PEDESTRIAN WIND ENVIRONMENT ASSSESSMENT-RESPONSE TO SUBMISSIONS

16 November 2018 CPP Project 8839

Project: The Star, Sydney (Modification 13)

Figure 1: Measurement locations in existing configuration

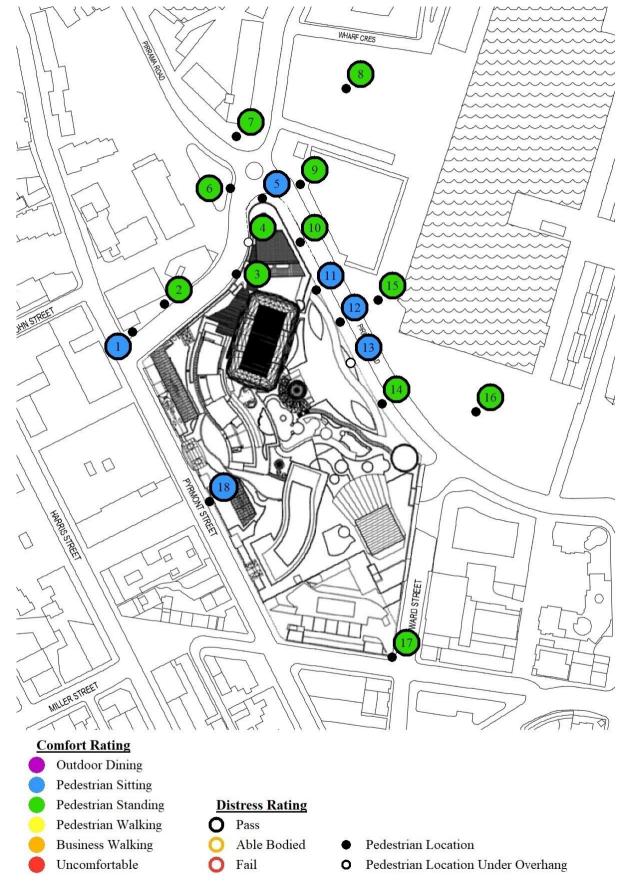
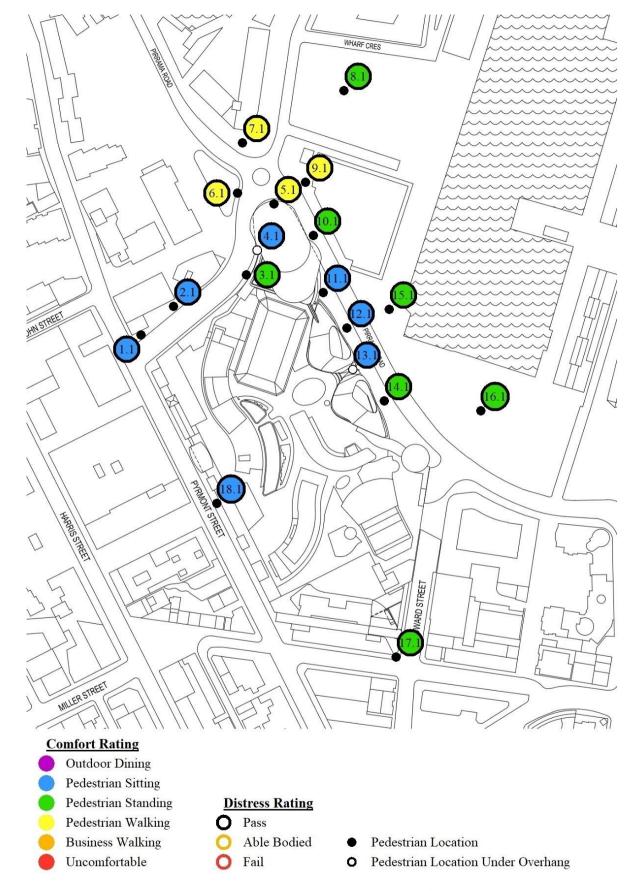
- 16. Update the Wind Impact Assessment as follows:
 - a) to allow for a comparison between the existing and proposed wind environments, confirm the 'as-existing' measurements for points 1 to 12
 - b) assess the impact of the development at the following additional points:
 - i) the pedestrian outdoor seating on Jones Bay Road
 - ii) the entrance to 10 Jones Bay Road
 - iii) Pyrmont Bay foreshore, opposite the Pirrama Road entrance/frontage
 - iv) Pyrmont Bay Park and Metcalf Park.
 - c) confirm whether the proposed mitigation measures at Level 59 Club Lounge Sky Terrace adequately address wind impact so that this space is functional for its intended purpose and does not pose a safety risk.
 - d) consider providing additional wind mitigation measures to improve the wind environment comfort level at point 6 from 'pedestrian standing' to 'pedestrian sitting'.

8. The proposal results in [...] wind impacts and other environmental conditions not contemplated on the grant of approval for the original application.

Wind Environment Assessment – MOD13 modification to the development as approved under MP08-0098, up to and including MOD 14. Further consideration of wind impacts at 16 Pyrmont Street are required as the submission is not explicit in the Wind Environment Assessment report. As it reads if pedestrian wind assessments result in measured wind conditions at ground level (16 Pyrmont Street home is on ground / not an apartment) showing transient spaces for pedestrian activities will be continued at a comfortable level. However outdoor seating for dining – our kitchen and living room open to outdoor living / dining decking and backyard (therefore long term stationary activities) will be exposed to wind speeds for longer periods / frequencies of time and it is recommended local amelioration such as vertical screening and landscaping surrounding seated areas are utilized to help improve local comfort conditions. The assessments also states additional awnings would be slightly beneficial for wind conditions and they would provide some shielding from wind and wind-driven rain. Design recommendations for SEGL based on the finding of the Consultant for the purpose of this development application also apply to 16 Pyrmont Street, our home is a roads width away from The Star. Who is going to provide 16 Pyrmont Street with amelioration for living conditions and shielding from the wind tunnelling and wind driven rain with Mod 14&Mod13 approval to build? NSW Government? City of Sydney council? The Proponent?

a) Multiple wind tunnel studies were conducted, including the test outlined in CPP report dated April 2018, to acquire ground level wind speeds surrounding both the existing site and the proposed Mod13 development site to allow comparisons of changes, if any, in the wind environment. The measurements are summarised in Table 1 and the measurement locations are presented in Figure 1 and Figure 2. Locations in close proximity of the tower experienced slightly windier conditions than in the existing configuration, however wind conditions remain suitable for the intended purposes of these areas. The remaining locations experienced similar wind conditions in both configurations.

b) Wind conditions at 10 Jones Bay Road (Location 6) were slightly windier with the addition of the Mod13 exhibited scheme and tower, however this level of wind is still suitable for the intended purposes of this area as a space for moving pedestrians.

Wind conditions within the pedestrian outdoor seating on Jones Bay Road (Location 3), Pyrmont Bay foreshore (Location 15), Pyrmont Bay Park (Location 16) and Metcalf Park (Location 8) experienced similar wind conditions in both existing and proposed configurations, and thus the Mod13 exhibited scheme had limited impacts on the wind environment in these areas.

A comparison of the measured winds from extensive wind tunnel studies around the existing and proposed site configurations, Figure 1 and Figure 2 respectively, shows the proposed Mod13 exhibited scheme will not have significant impacts on the existing wind environment surrounding the development site on the ground plane. Some locations close to the tower (locations 5, 6, 7 and 9) have become slightly windier, however these levels of conditions remain suitable for moving pedestrians along the footpaths. Furthermore, wind conditions at some locations have slightly improved with the addition of the tower (locations 2 and 4).

The wind tunnel studies conducted have shown that the outdoor area of the 16 Pyrmont Street building (Location 1) experienced similar wind conditions in both the existing and proposed development site configurations, where the wind conditions were classified as 'pedestrian sitting'. Therefore, the impact of the proposed tower on this area will be limited.

Wind conditions measured within close proximity of the 16 Pyrmont Street building (Location 2) improved in the proposed configuration, classified as 'pedestrian sitting' under Lawson comfort criteria. This level of winds would be considered suitable for outdoor café style seating areas.

A comparison of the measured winds from the extensive wind tunnel studies around the existing and proposed site configurations, Figure 1 and Figure 2 respectively, shows the proposed Mod13 exhibited scheme will not have significant impacts on the existing wind environment surrounding the development site on the ground plane. Some locations close to the tower (locations 5, 6, 7 and 9) have become slightly windier, however these levels of conditions remain suitable for moving pedestrians along the footpaths. Furthermore, wind conditions at some locations have slightly improved with the addition of the tower (locations 2 and 4).

Figure 3: Proposed landscaping along Pirrama Road

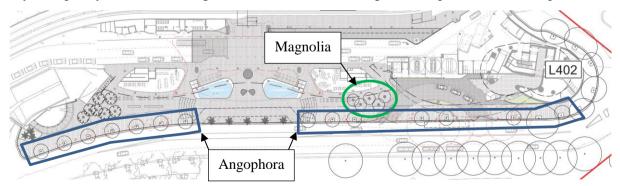
The Star Casino's decision to exclude a wind assessment as part of the development application because wind mitigation measures have been added to the proposal since it was first planned lacks transparency and is unacceptable. The height of the tower has increased since it was first proposed and higher buildings cause greater wind impacts.

The environmental impact statement's claim that "conditions on the ground plane were classified as suitable as public access ways" does not tell us whether it will be comfortable for people to set at Pyrmont Bay Park, or walk or stand along the footpaths on a windy day.

The measured wind conditions from the wind tunnel study along Pirrama Road (Locations 10 to 14) would also be considered suitable for short-term stationary activities such as taxi ranks, bus stops and kiss and ride zones. Wind conditions suitable for long-term stationary activities such as café dining could be achieved with local wind mitigation measures such as temporary vertical screening and dense landscaping - this will be achieved by the proposed magnolia and angophora tree clusters at the two proposed F&B venues on Pirrama Road as evident in the landscape package, Figure 3. During windy days, temporary vertical screening could be used around seatings areas to provide additional protection.
